# Responses to Anonymous Referee #1

MS No.: hess-2020-59

Fig. 2 The pipeline and manholes of the sewer systems in the study area.

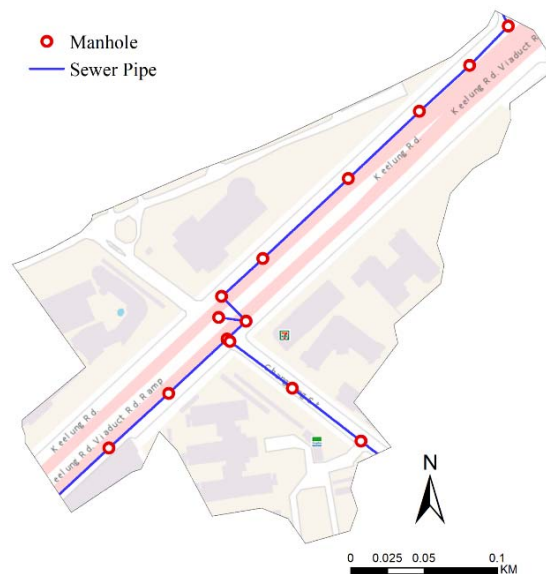
- 7 The study talks about a computational sewer model being used, but provides no details of this and where sewers were or how flow was accounted for.

**Response:** The pipelines and manholes of the sewer systems are displayed in the following Figure:

Fig. 4 Conceptual flowchart of this study (the VGI photo was adopted from PTT, Taiwan)

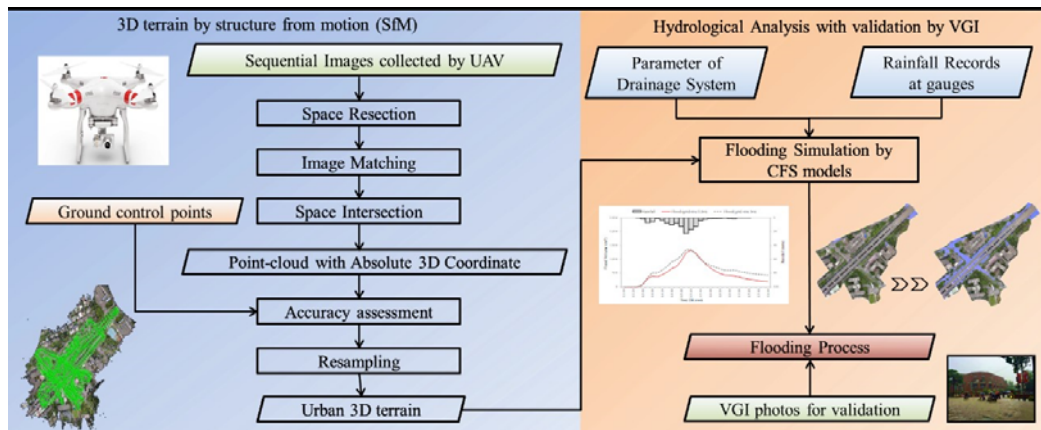
- 9 The paper provides irrelevant equations and information about DEM reconstruction and camera lens distortion (section 2.1). These are a red herring and completely irrelevant. The authors used Pix4D to do their aerial image processing and have not implemented the equations themselves. Pix4D or Agisoft Metashape are the appropriate software packages for this type of work, but the authors should spend more time discussing the appropriate workflow for data processing. It is likely that they did not follow a recommended workflow since they only used 3 ground control points.

**Response:** We revised the Section 2.1 by adding necessary information about the determination of roughness and DEM for areas of vegetation and underneath the viaduct. The Pix4D workflow of data processing is displayed in the following Fig. 4 and is identical to the manual suggestions (Pix4D, 2017). The basic theories of collinearity and lens distortion are kept in the manuscript for reader's reference. According to the Pix4D manual, three GCPs have met the basic requirement for UAV image processing and validation. We have added some discussion on the GCP requirement in the revised manuscript.

Fig. 5 The processed (a) orthophoto and the DEMs with spatial resolution of (b) 0.5 m (c) 5 m

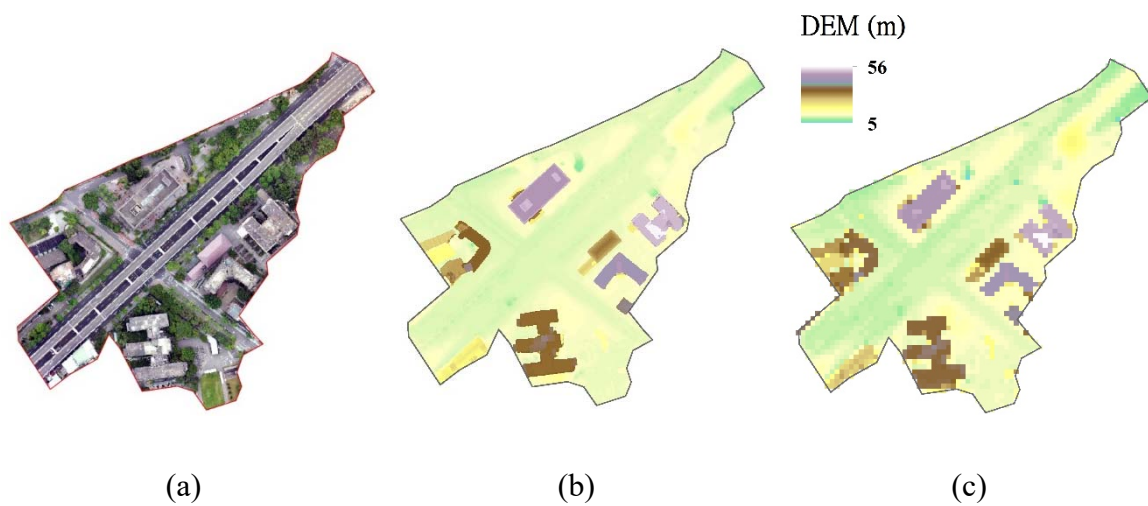
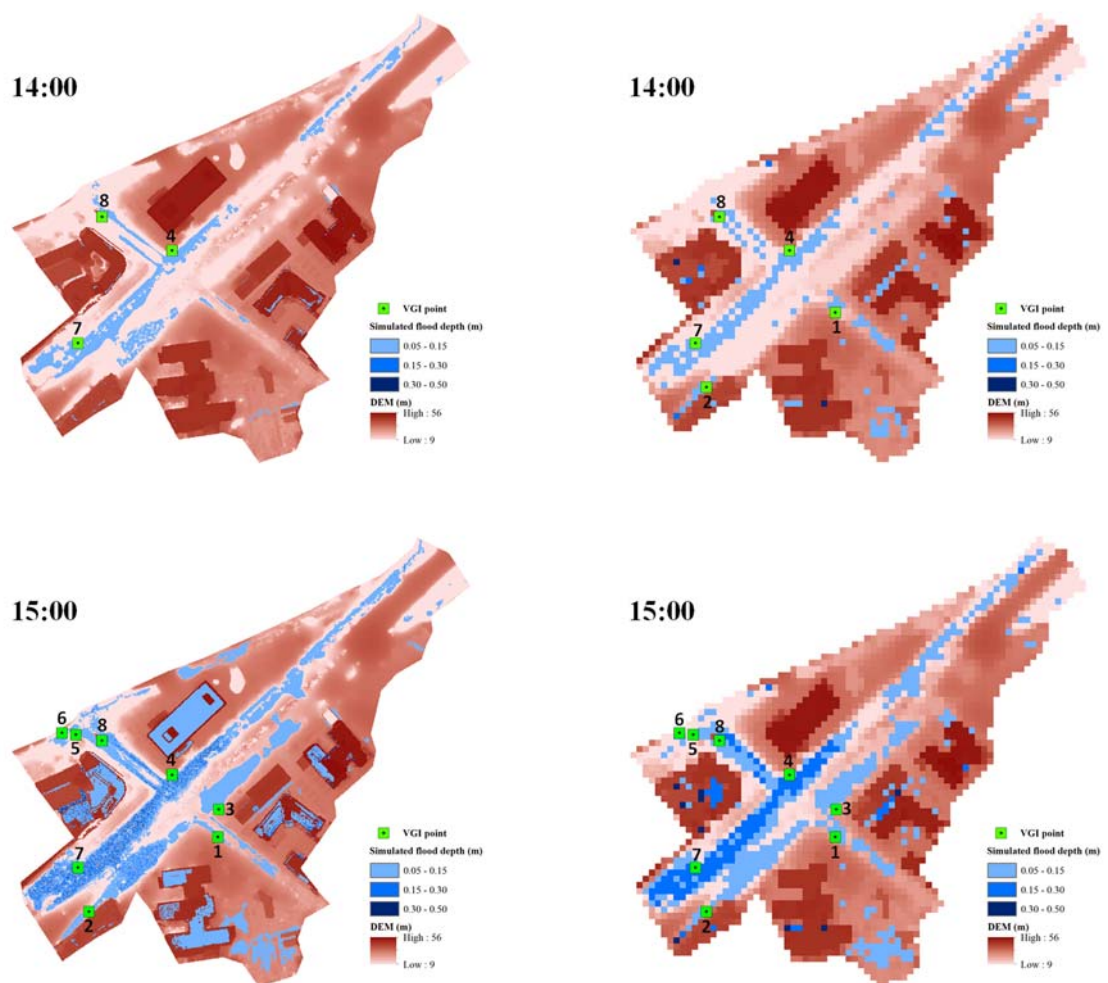
- 13 Scaling of figures 7 and 8 is poorly selected and shows nothing of the fine scale DEM at ground level which is critical for the flood modelling. The selection of this scaling raises questions as to whether it was selected on purpose to hide a poor quality DEM at ground level.

**Response:** The scaling of the two figures are based on a continuous classification of DEM automatically generated by a GIS software. The ground levels are not displayed in detail because the height of buildings outweighs the variation of ground levels which results in the stretch of color bar. In order to highlight the details of ground level, the scales of these two figures have been adjusted in the revised manuscript and are displayed as below:
